Addendum No. 1 **February 14, 2017**

Project: **Lansing Pathway Promise**
Project: SB-0006
Fairview Additions and Renovations

ADDENDUM #1

Project No.:	16-0400	**Date:**	February 14, 2017
Project:	Lansing Pathway Promise SB-0006 Fairview Additions and Renovations Ingham County, Michigan	**A/E Firm:** **Project Manager:**	C2AE Steve Jurczuk
Owner:	Lansing School District 519 West Kalamazoo Street Lansing, MI 48933

1 SANITARY & VENT ISOMETRIC - EAST WING

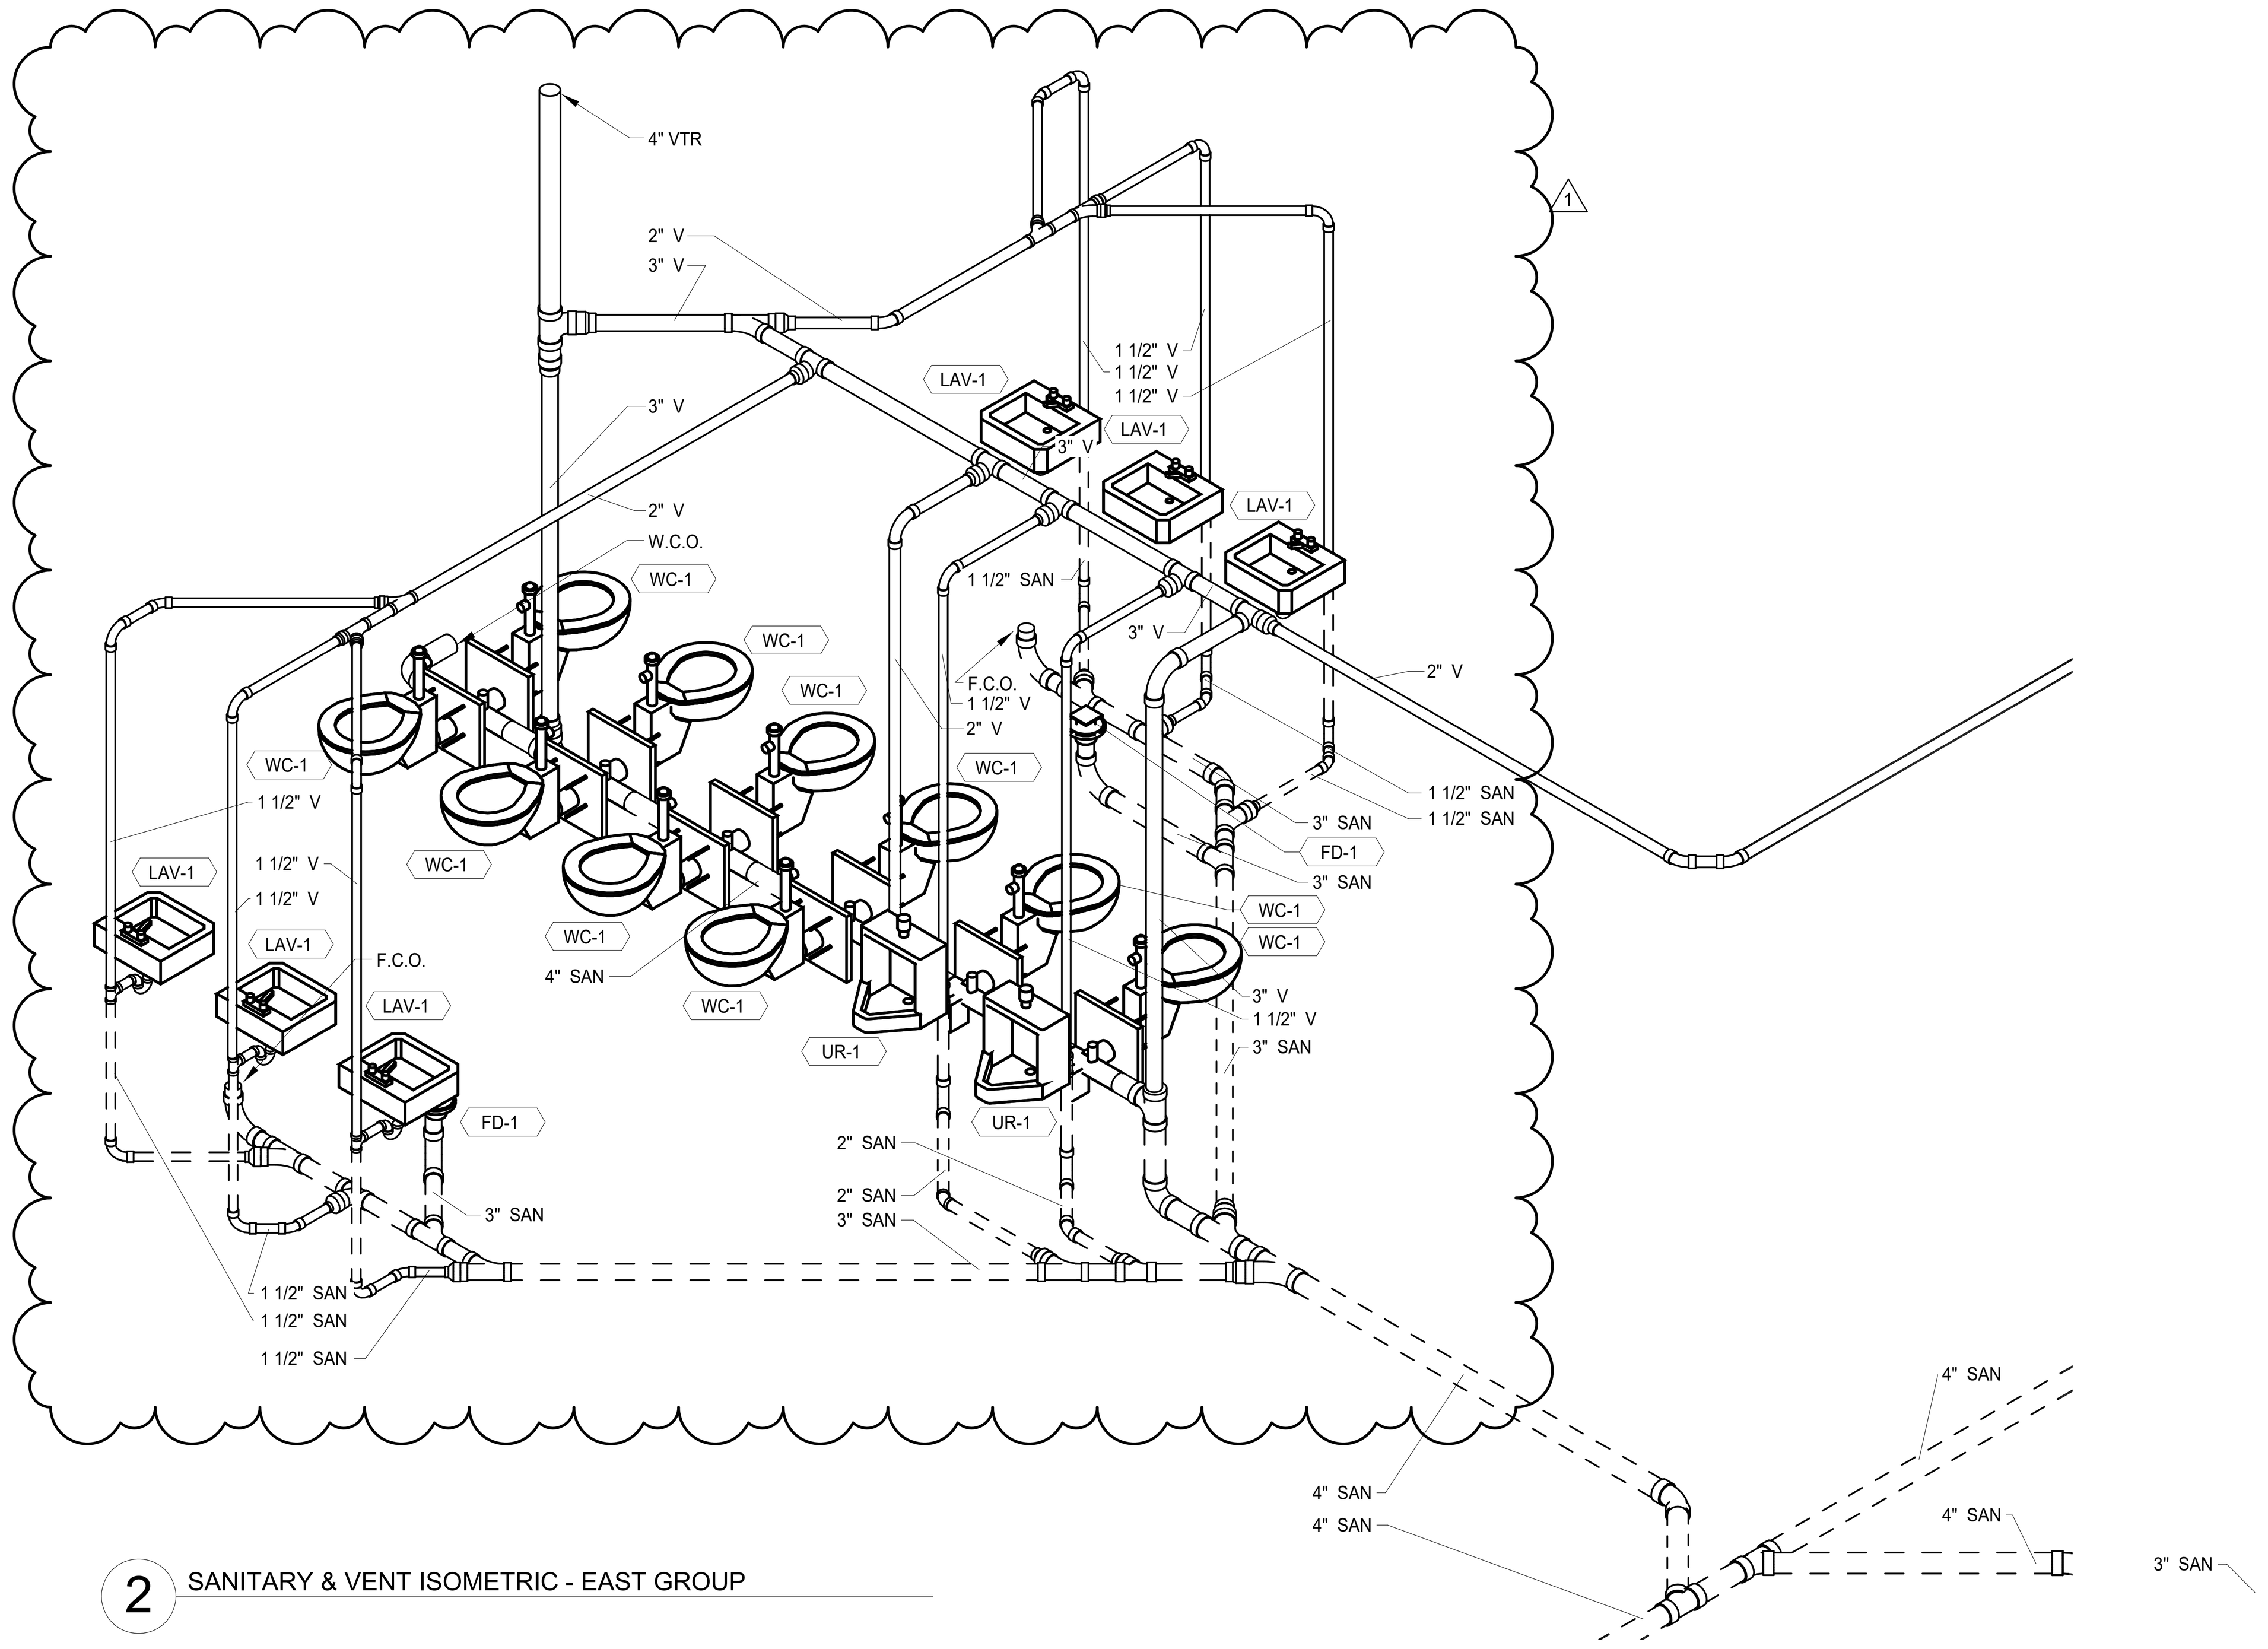
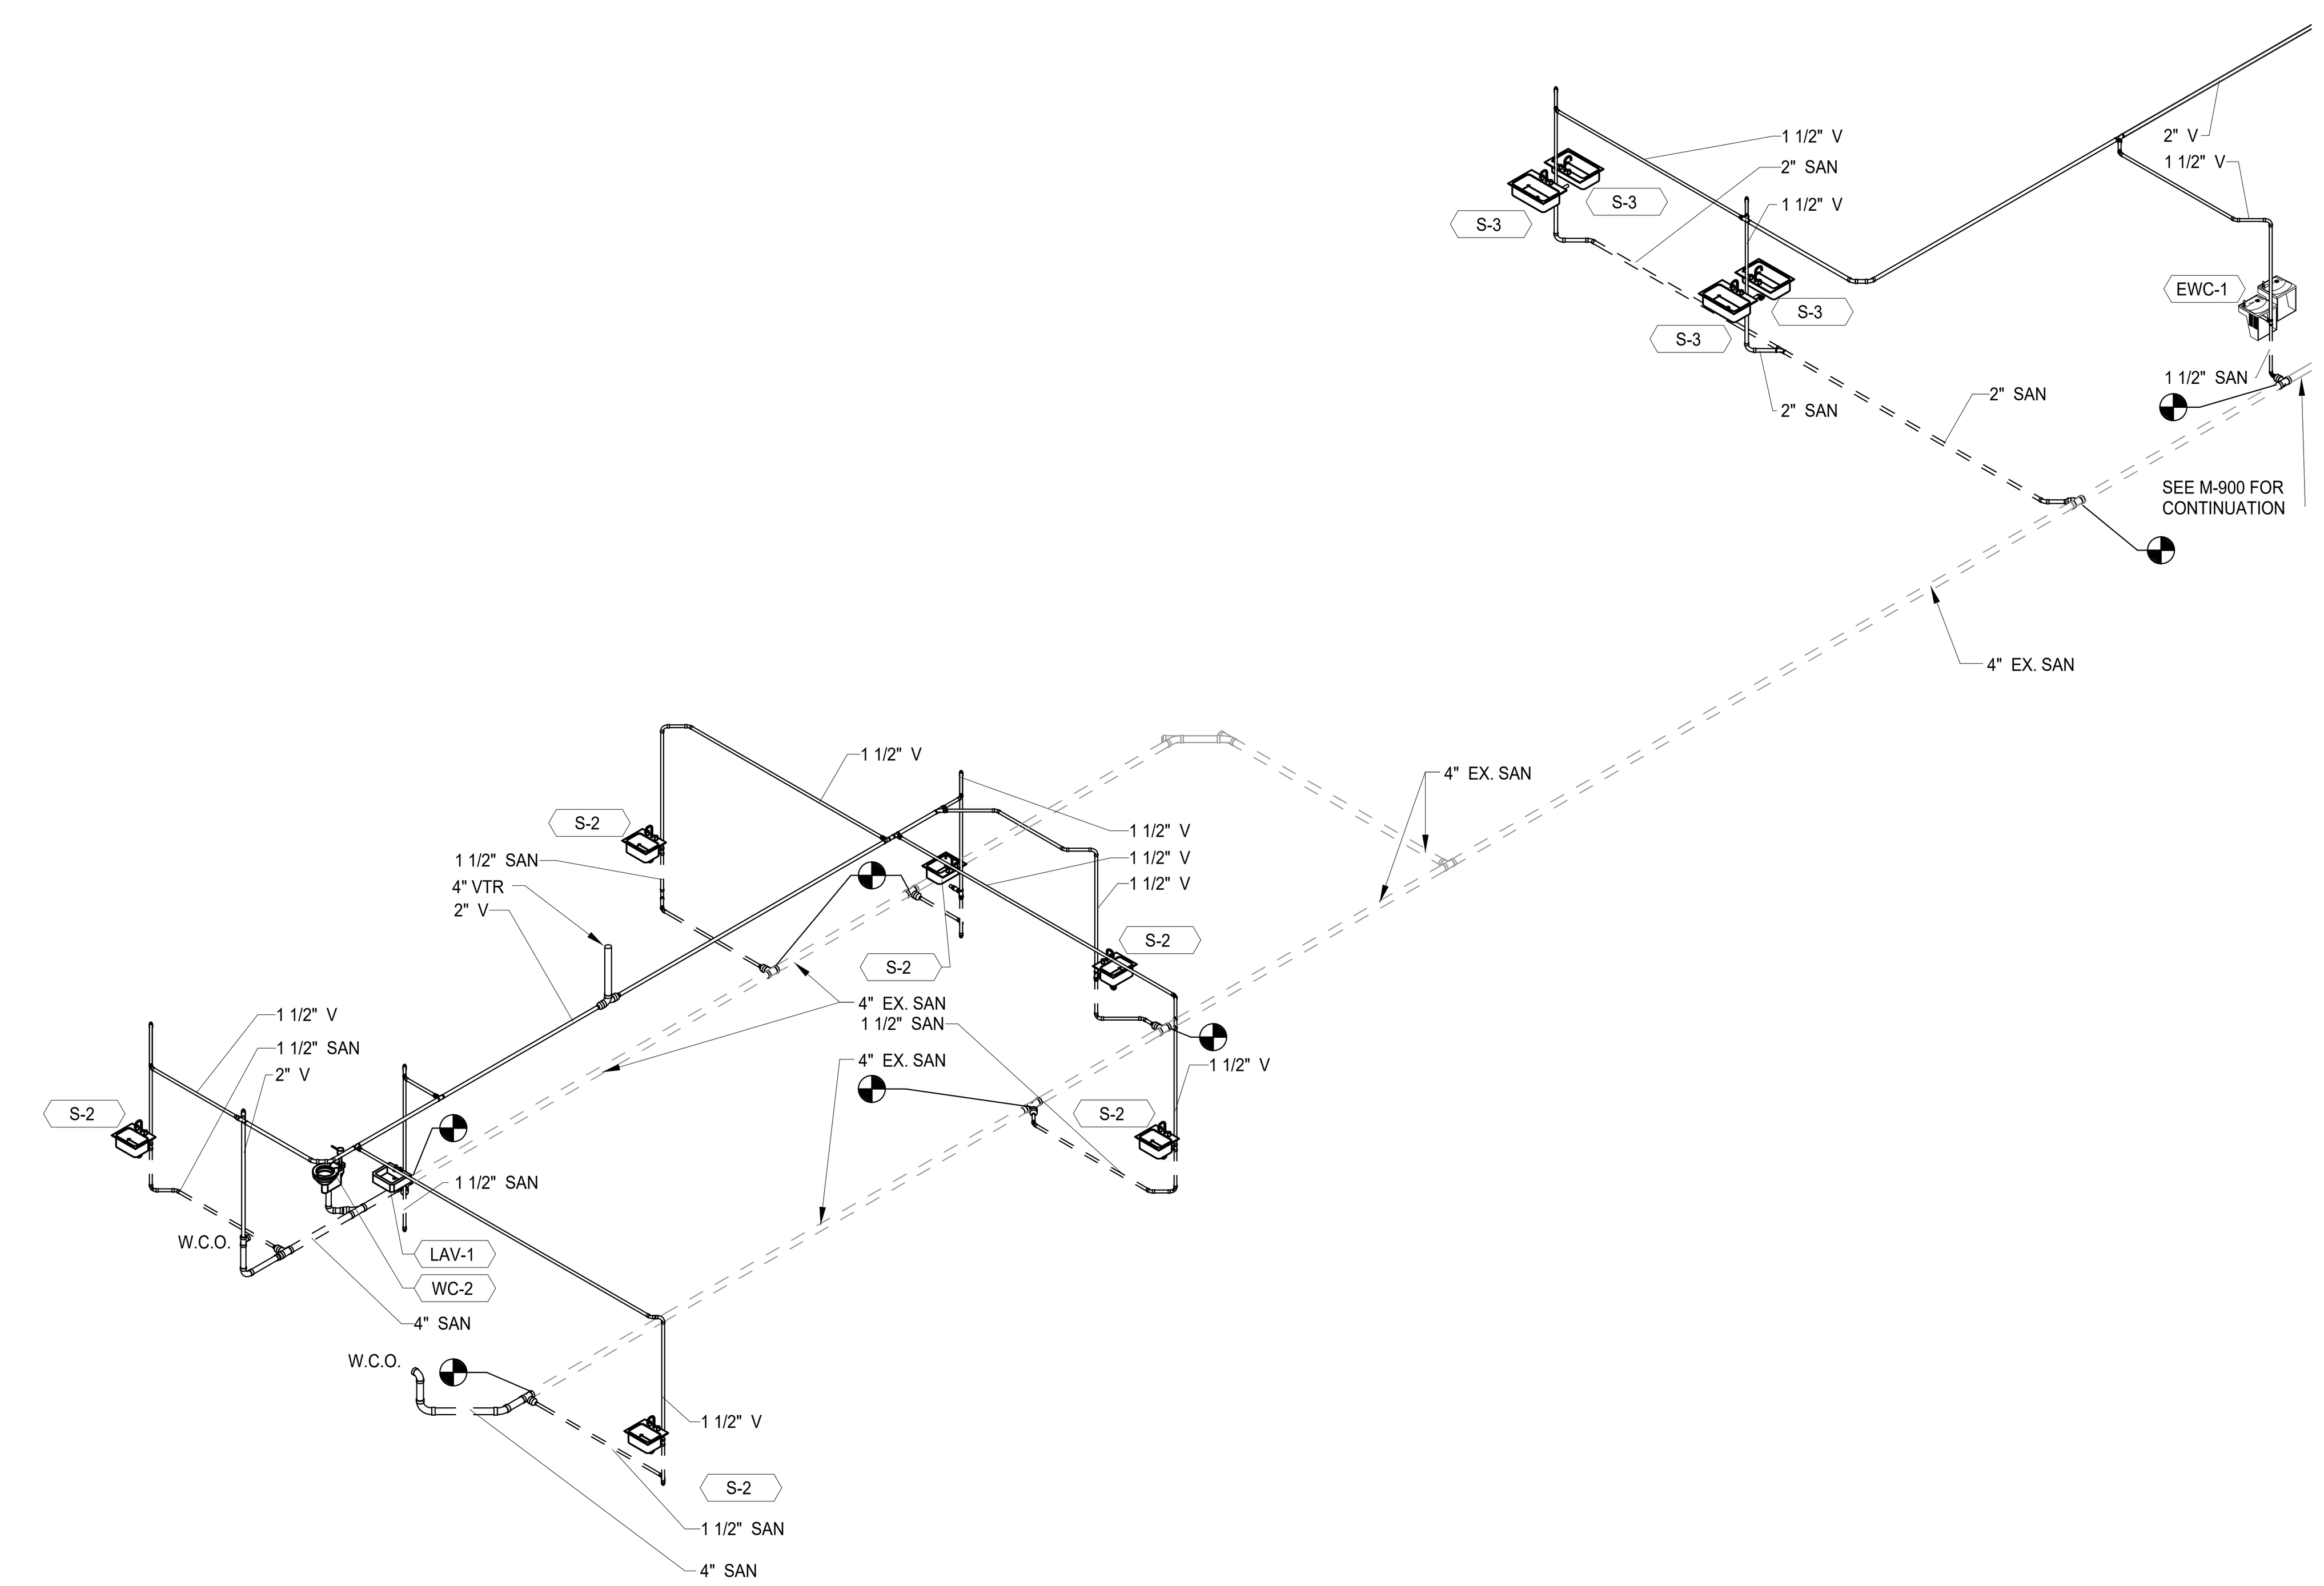
A1.38 Refer to Sheet P-901 (reissued):
REVISE sanitary piping isometric for new bathroom fixture layout as shown.
